WILLOWTREE PLANNING

Wentworthville Northside West Clinic Extension SSD-17899480

TABLE 1. COUNCIL & AGENCY COMMENTS 21.09.2022		
A.	Cumberland Council Response	Applicant Response
1.	Council maintains the objection to the development application with regard to the proposed breach in the development standards. Council notes that the proposal has attempted to address the issues raised notably by reducing the building height breach from 30.7% to 24.5%. Matters raised in the objection previously submitted however continue to remain.	A comprehensive Clause 4.6 variation was submitted with the RtS which addressed the mandatory components of Clause 4.6, being: 1. Objectives of the standard 2. Objectives of the zone 3. Why the standard is unreasonable and unnecessary 4. Environmental planning grounds for the variation All of the above have been addressed satisfactorily which demonstrate the variation is supportable and justified, having regard to the site conditions, nature of the use, surrounding land use and resultant impacts.

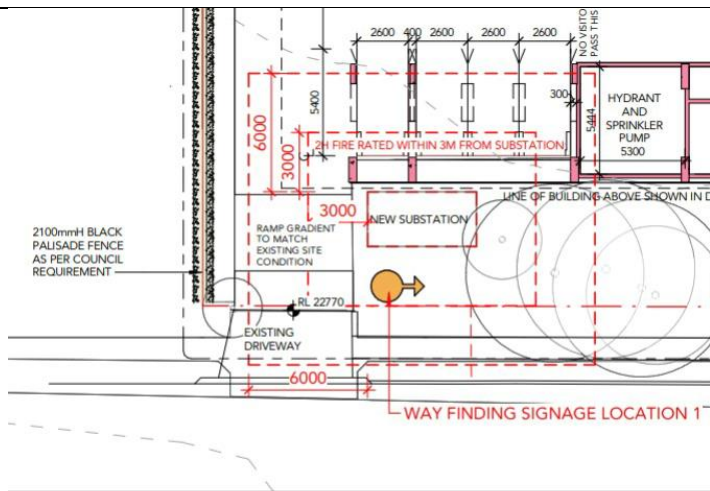
B. Biodiversity & Conservation		
1.	Biodiversity, trees and landscaping EHG has reviewed the letter prepared by Ecological Australia dated 28 July 2022 relating to the removal of the five additional trees and is satisfied that the additional tree removal will not affect the outcomes of the Biodiversity Development Assessment Report, dated 15 November 2021. In relation trees on site, EHG notes the following.	A further review of this requirement has been undertaken and is located at Attachment 1 .

- An additional six trees have been incorporated into proposed landscaping for a total of 13 new tree plantings on site. Of the 13 trees proposed, five are dwarf species. - Based on the additional information provided and communication with Cumberland City Council, EHG has confirmed that tree 47, located within the Council reserve, has been approved by council for removal. - EHG previously noted that trees 41, 48 and 49 will be subject to major encroachment into their tree protection zone (TPZ) from the proposed development. Australian Standard 4970:2009 Protection of Trees on Development Sites provides a range of actions that should be undertaken in this scenario, the first of which is to determine the location and distribution of the roots through non-destructive investigation methods. This investigation is the first step in determining if the subject trees will remain viable post development. This has not been undertaken. EHG recommends the previously requested information in relation to trees 41, 48 and 49 be provided.

1 DA Overall - Ground Floor
Scale: 1 : 200

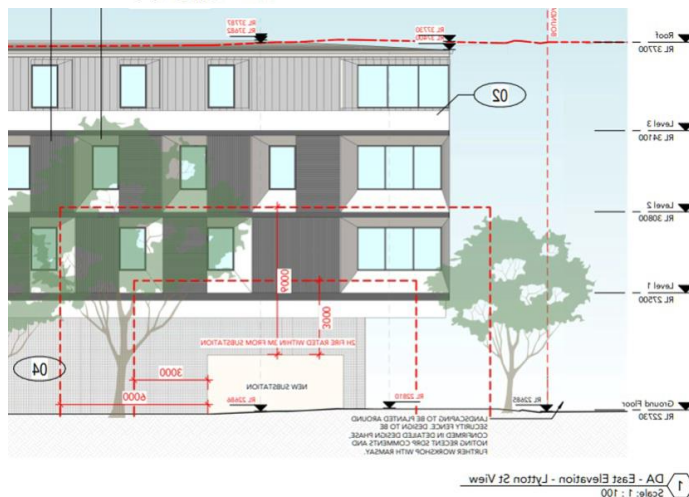
C.	Endeavor Energy	
1.	It is Endeavour Energy's experience in dealing with the fire restriction for padmount substations that any openings such as garage doors and any form of glazing (in particular opening windows) cannot achieve the required rating. Partly for this reason the Terms of Restriction on the Use of Land for Fire Rating of Buildings has recently been amended (please refer to the attached copy) and now includes the following additional requirement. No doors or opening windows are permitted to be erected within the restriction site on the external surface of a building within 3 metres from the substation footing. As shown in the following extracts of the Architectural Plans it appears there may be opening windows within the fire restriction area for the new padmount substation.	No windows will be operable as this is a mental health facility and operable windows are non-compliant under the Australian Health Facility Guidelines. Any doors to the Hydrant & sprinkler room will be located outside the 6m perimeter.

Given the available front building setback, relocating the new padmount substation to the front boundary could be preferable. This should overcome the need for any fire rated construction to the building, avoid the need for an easement for the associated underground cables and is preferable from a prudent avoidance perspective.

Unable to move due to Council Stormwater pits.
